Development Services Staff Report

File Number	PL2021-063
File Name	PRELIMINARY DEVELOPMENT PLAN – Climate controlled storage facility
Applicant	Lakewood Self-Storage, LLC
Property Address	4101 NE Port Dr.
Planning Commission Date	April 22, 2021
Heard by	Planning Commission and City Council
Analyst	Jennifer Thompson, Senior Planner
Checked By	Hector Soto, Jr., AICP, Planning Manager and Kent Monter, PE, Engineering Manager

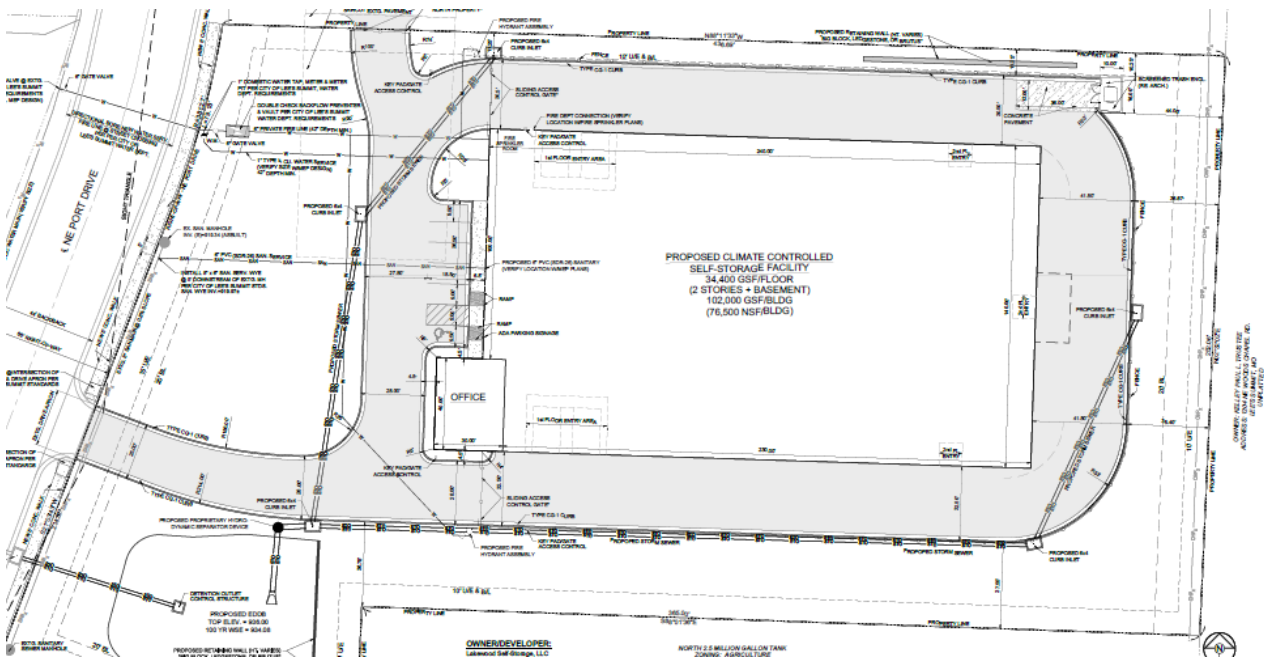
Building Materials. Conditional material proposed.

- Proposed – smooth architectural metal paneling
- Required – Masonry, concrete, stucco, and glass. Metal to be used in an incidental role or other architectural metal siding as approved by the Planning Commission and/or City Council.
- Recommended – Staff recommends approval of the conditional material request to allow the metal as shown on the plans. As the quality of metal building materials has improved, the use of said materials has increased in the areas of industrial, commercial and residential construction. The other materials proposed for the remaining portions of the elevations will be a combination of brick, stone, glass, and aluminum storefront glass windows.

The smooth metal panels have deep flutes that will cast shadow lines across the building and contrast with the texture of the brick and stone. This will exemplify the appearance of a modern storage facility by creating depth, contrast, and texture for a truly dynamic design.
